Author's General Response to Reviewer #3

Figure 1 Meridional section of potential density (σ_2 , referenced to 2000 m) across the Tsugaru Strait, averaged over 2012. (a) ZSTAR, (b) HYBRID, and (c) HYBRID–ZSTAR difference.

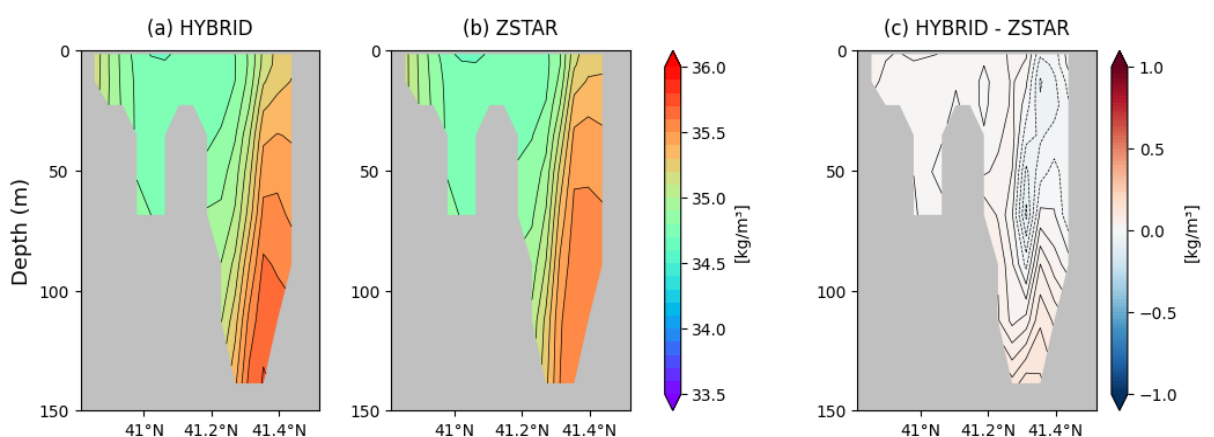
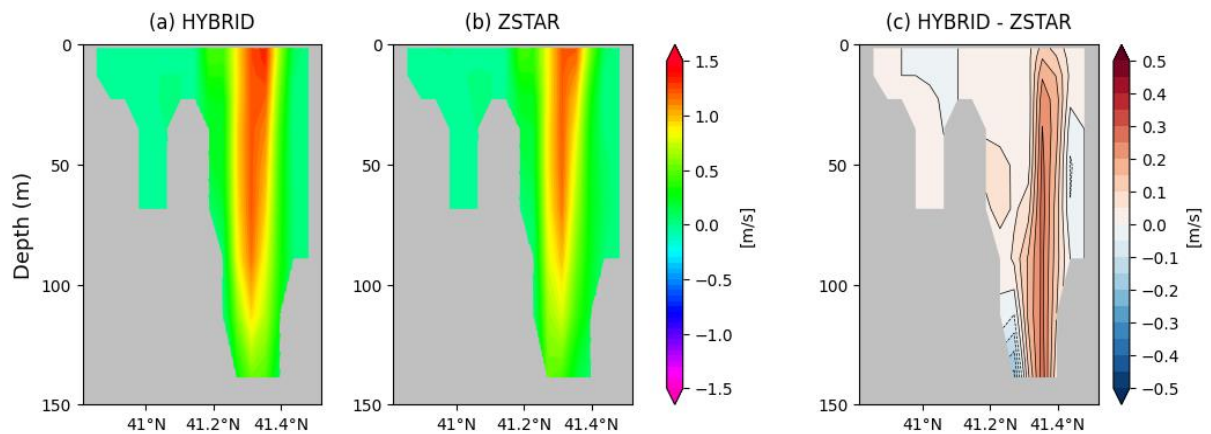
Section 3.4: It would be useful to include here and/or in Section 4 a discussion on how the volume transport differences come about with the different vertical grids. It seems that, while not perfect, z-star was consistently better than the hybrid grid.

- We thank the reviewer for this valuable suggestion. This comment aligns with another reviewer's question regarding how the vertical coordinate system influences the simulated volume transport through major straits. We have clarified this connection in the revised manuscript (Section 4.2), explaining that both configurations used identical bottom drag formulations and free-slip lateral boundary conditions; thus, the transport differences mainly arise from how each vertical coordinate represents stratification and the associated baroclinic pressure gradients. In particular, HYBRID tends to preserve steeper isopycnal slopes and stronger density gradients, which may locally enhance the pressure-gradient force and result in stronger along-strait velocities, while ZSTAR's smoother vertical discretization dampens these gradients and yields weaker transports. (line 758-764)
